From: Mess, Camie
Sent: Tuesday, February 27, 2018 12:06 PM
To: jmullen@rothjackson.com
Subject: BAR Action- February 21, 2018 - 501 West Main Street

Certificate of Appropriateness

BAR 18-02-05
501 West Main Street
Tax Parcel 320175000, 320176000, 320177000
Quirk Hotel, Owner/ Jennifer D. Mullen, Esq., Applicant
Additional demolitions

Partial Demolition and Proposed Massing

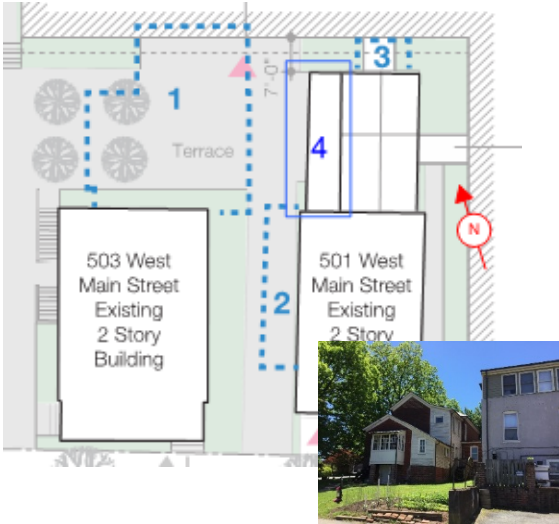
This correspondence is to provide you with a summary of our recent site visit to 501 W.. Main Street in Charlottesville, VA 22901. We visited the site to review the condition of the porch addition to the W. Main street structure. This portion is the northern part of area 4 in the figure below.

This structure appears to be an enclosure of an existing covered porch and stair or an entirely separate structure. Unlike the rest of the structure it is a wood framed and clad addition. We noted the highest degree of deterioration at this portion of the structure.

The deterioration is a result of poor initial construction, wood rot, differed maintenance and water washing through the mortar joints. There is also cracking at the masonry foundation wall at the joint of this structure.

In our opinion removal of the addition (highlighted) will lessen the demand on the wall. This along with necessary rebuilding of the openings will

The proposed selective demolition can be carried out without structural ill effect to the existing original structures. In the case of the porch addition the removal will have a beneficiary effect on the portion of the structure to remain.

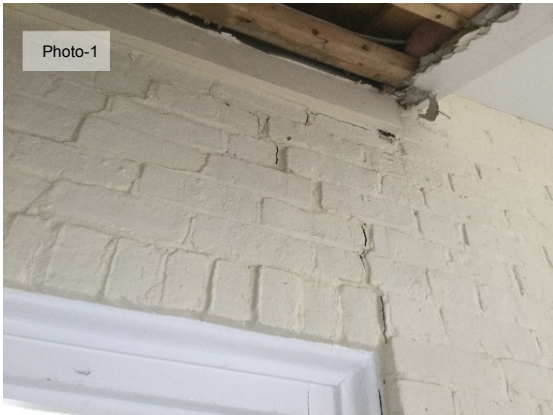
At an interior (but likely originally an exterior) doorway we observed cracking and displacement of the masonry (see photo-1). This is a sign of an ongoing structural problem.

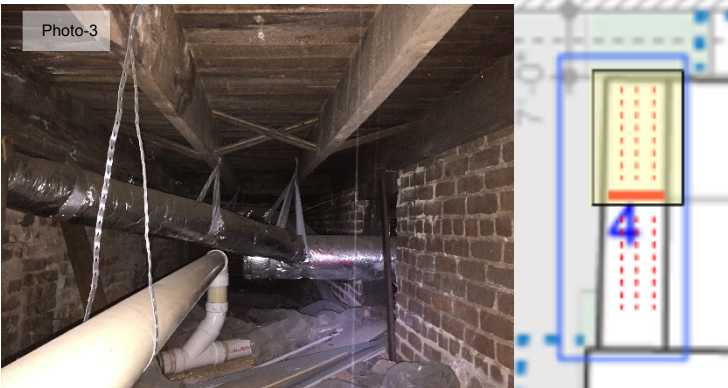
The framing of the roof over this portion in not an extension of the main roof rafters but a scabbed on 2x4 to the original framing (see photo-2). This alone does not significantly increase the load on the wall to account for the cracking observed.

PROPOSED LANDSCAPE PLAN

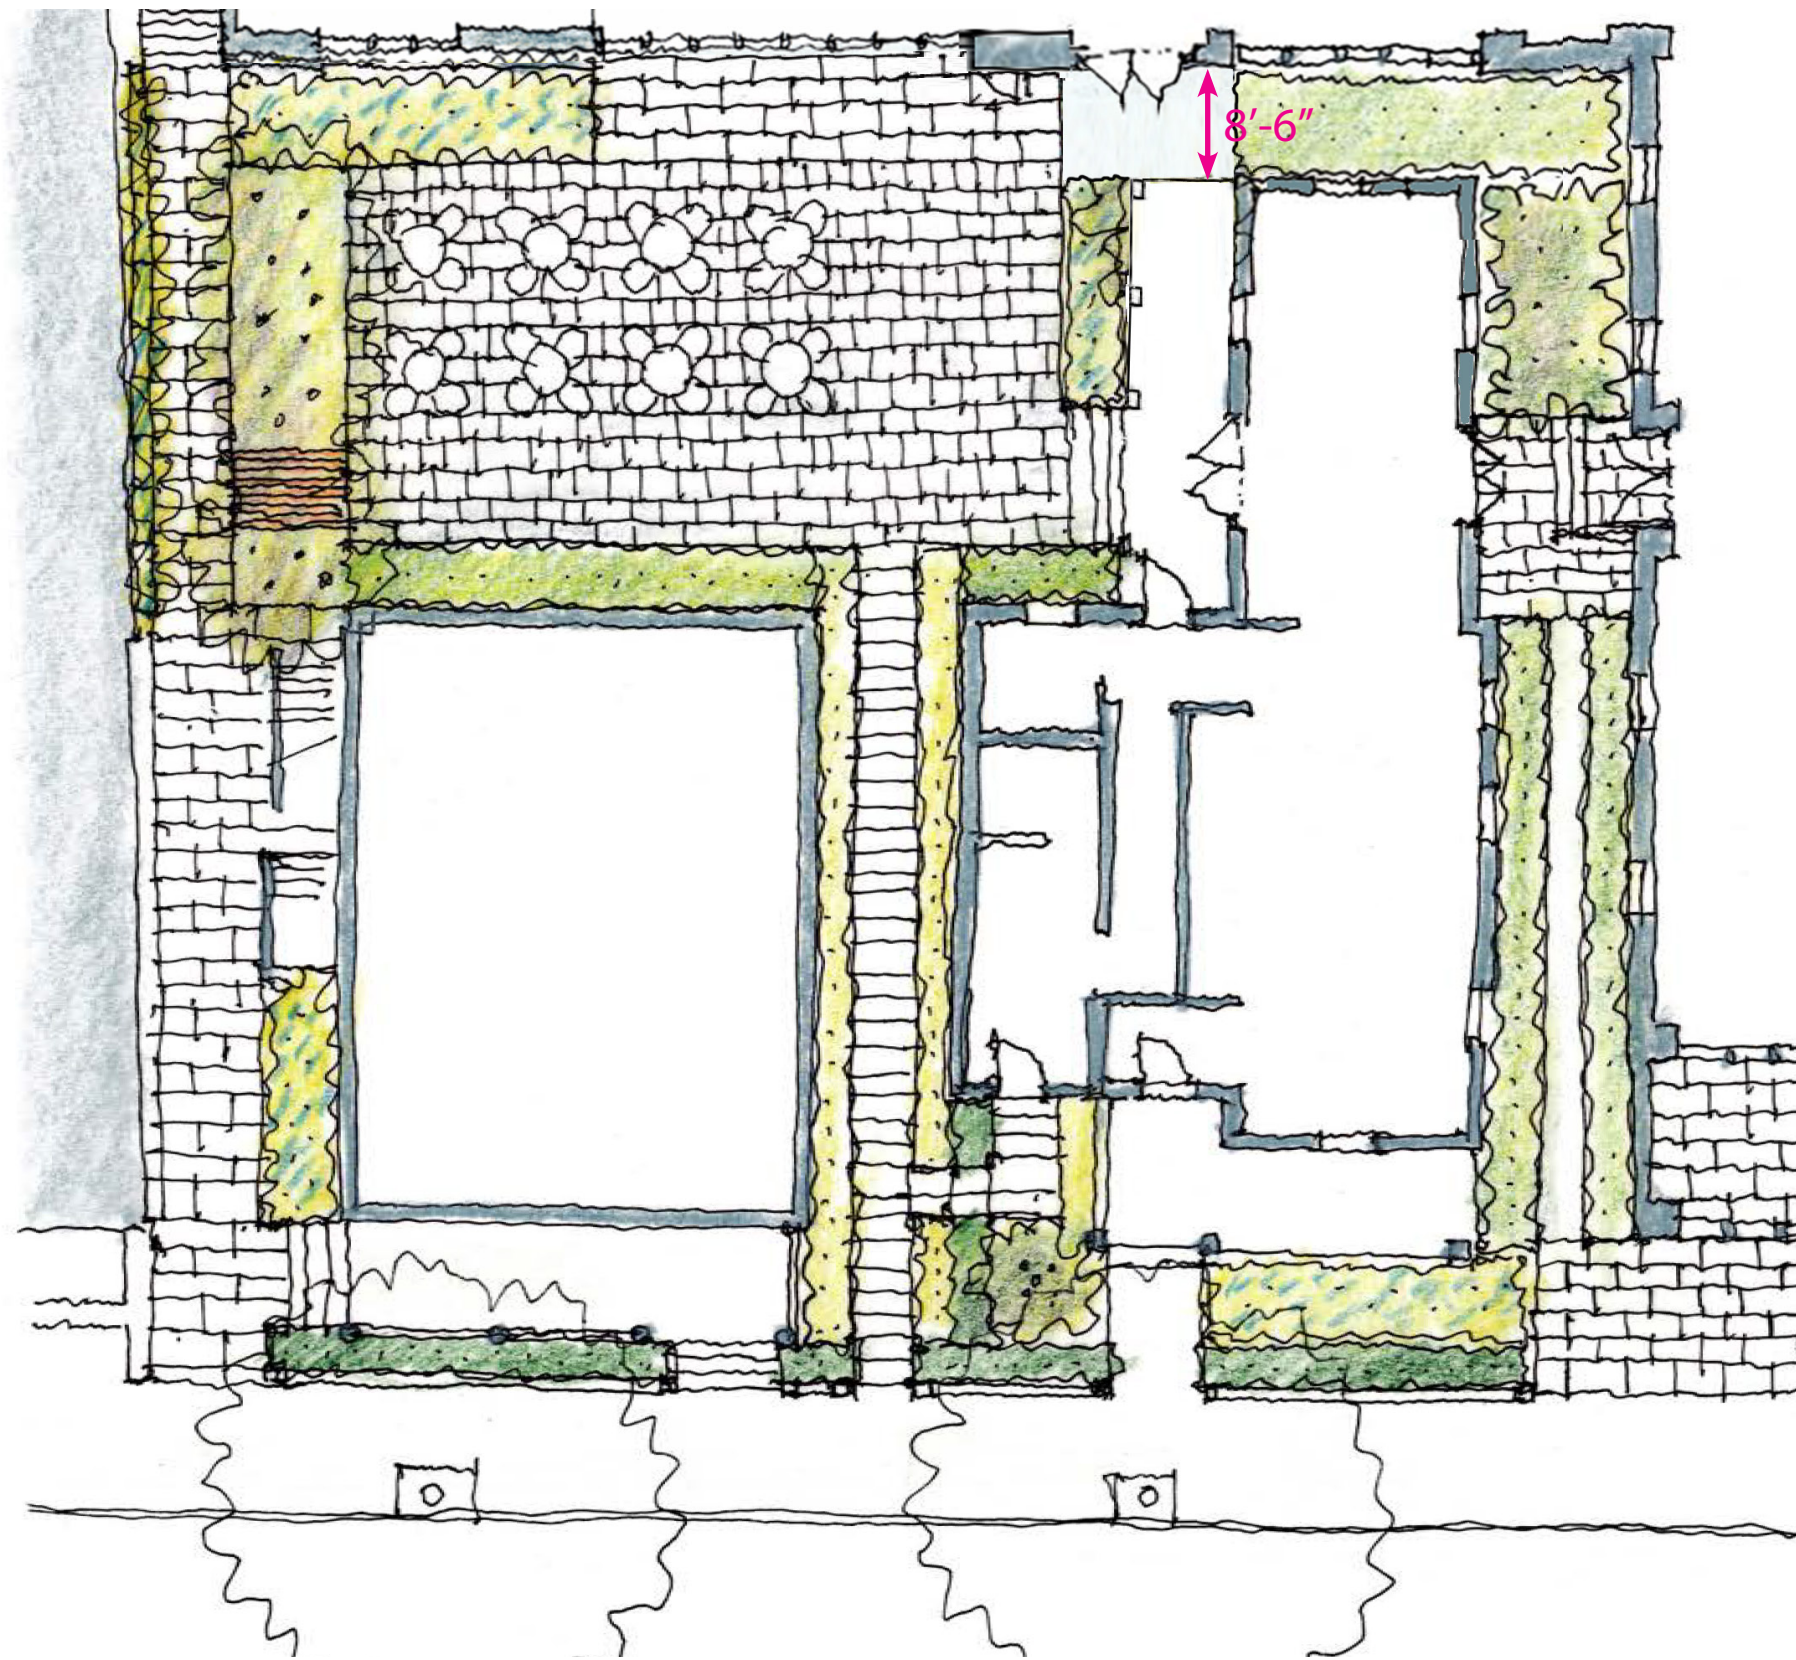
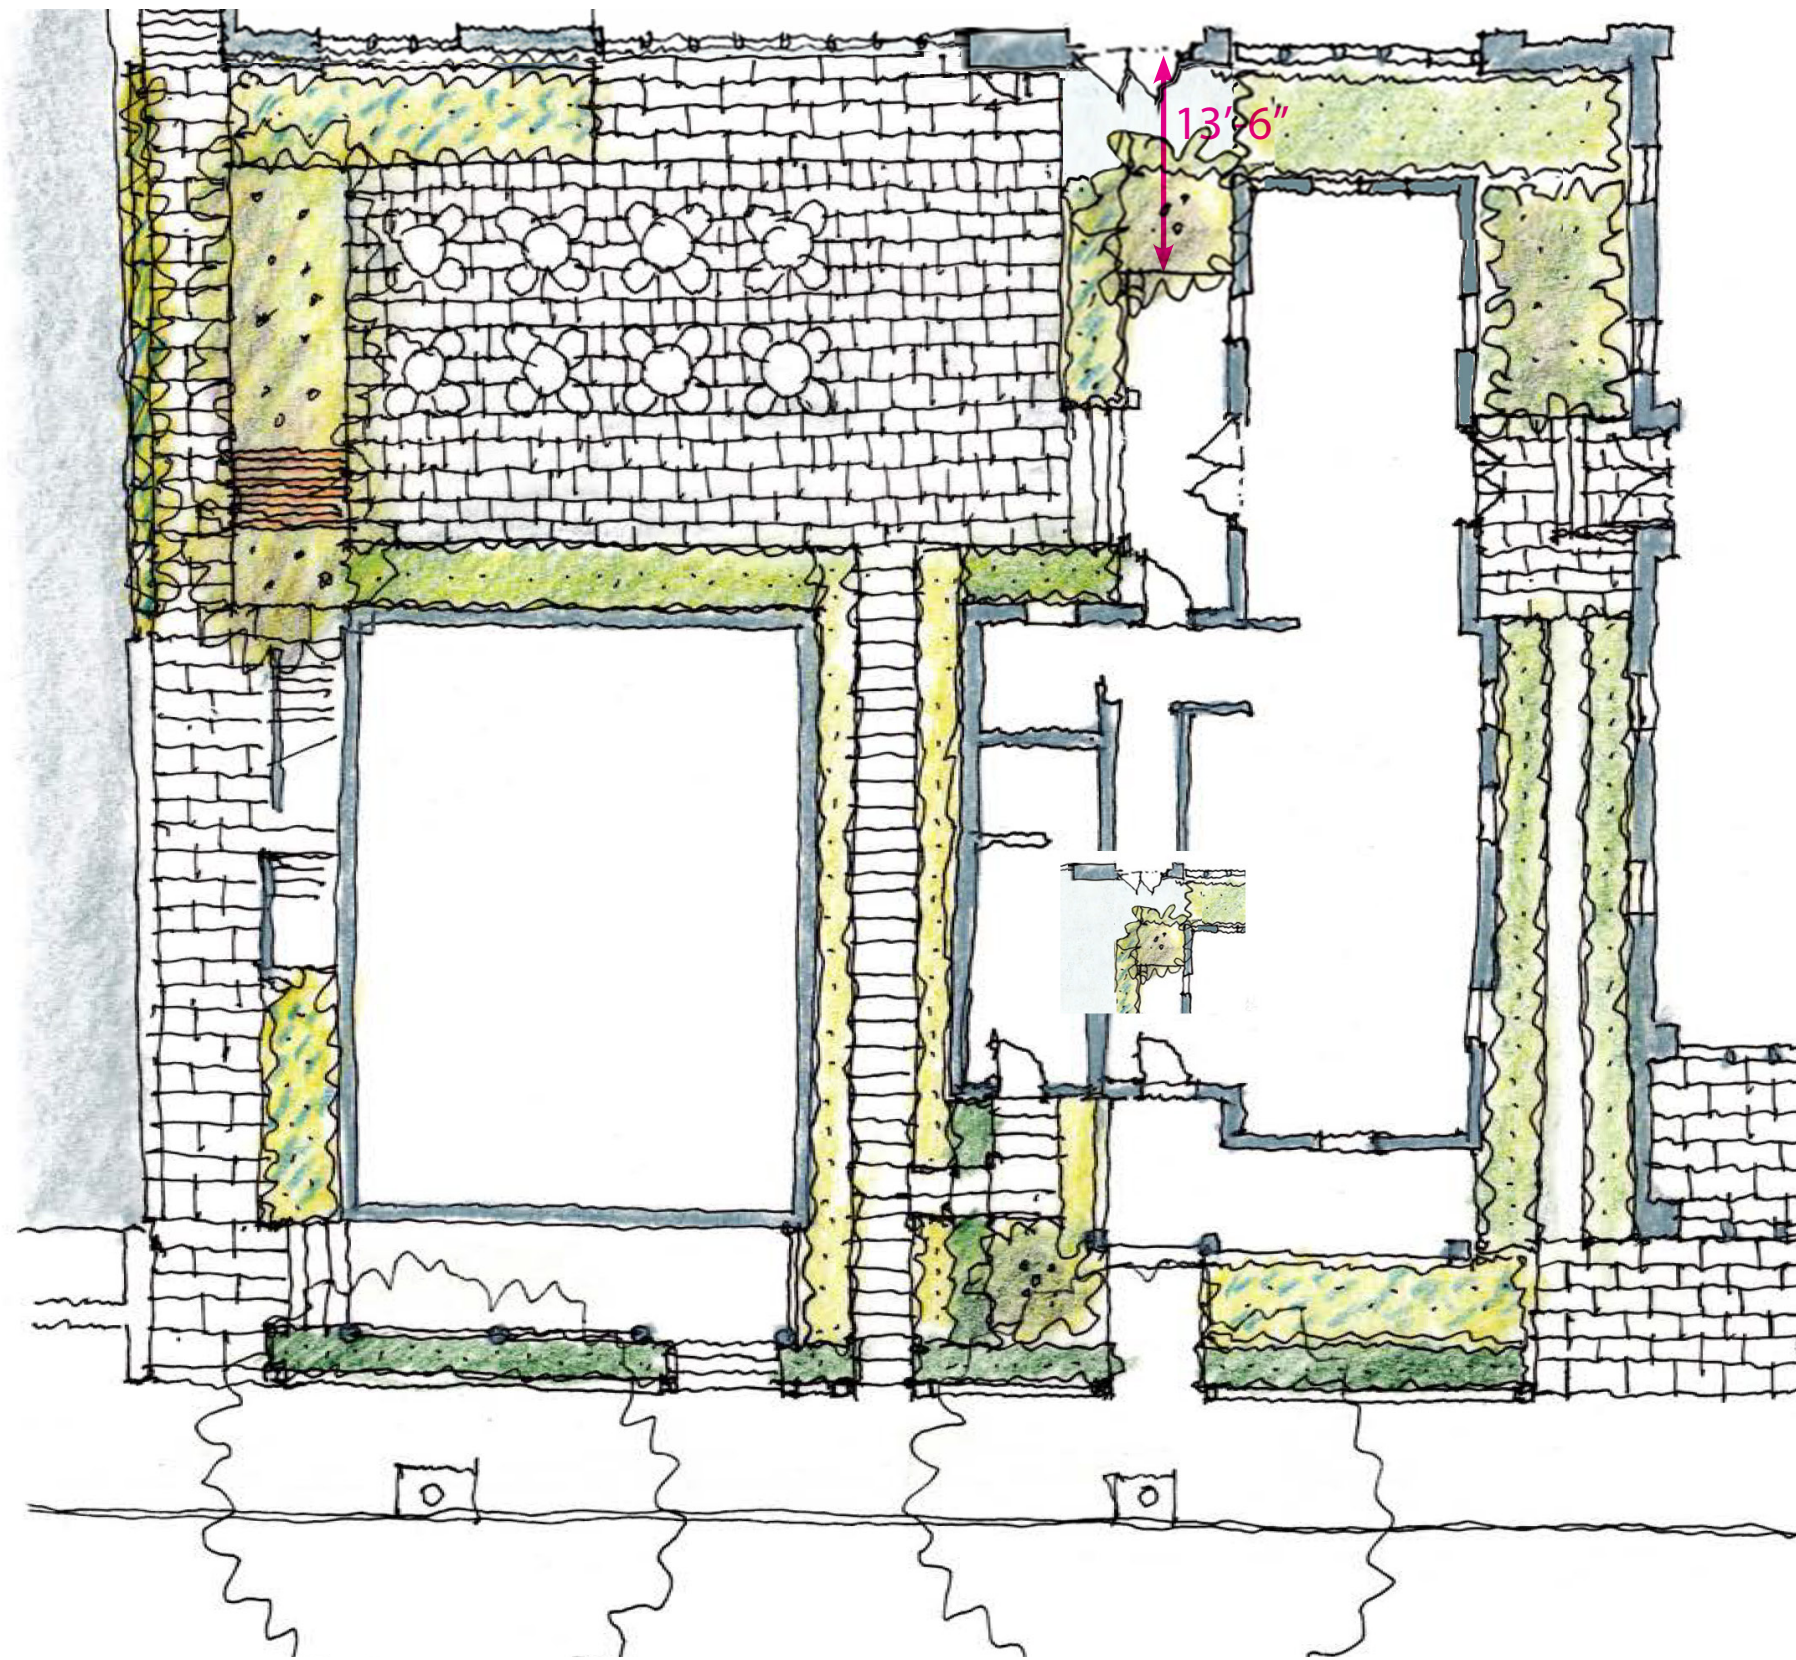
The applicant is requesting the demolition of the north porch on 501 West Main Street (added between 1896 and 1902) and proposed massing changes to the porch area.

The BAR previously discussed the partial demolition of the north porch on 501 West Main Street and the proposed massing changes to the porch area, and there was general agreement with the

board to allow the demolition. Demolition of the small office addition, identified as structure 2 on Page 8 of the applicant's 20 February 2018 submittal, has been removed from the application.

Schwarz moved: Having considered the standards set forth within the City Code, including City Design Guidelines for New Construction and Additions and for Demolition, I move to find that the partial demolition and proposed massing changes satisfy the BAR's criteria and are compatible with these properties and other properties in the Downtown ADC district, and that the BAR approves the application as submitted. Earnst seconded. Approved (5-0).
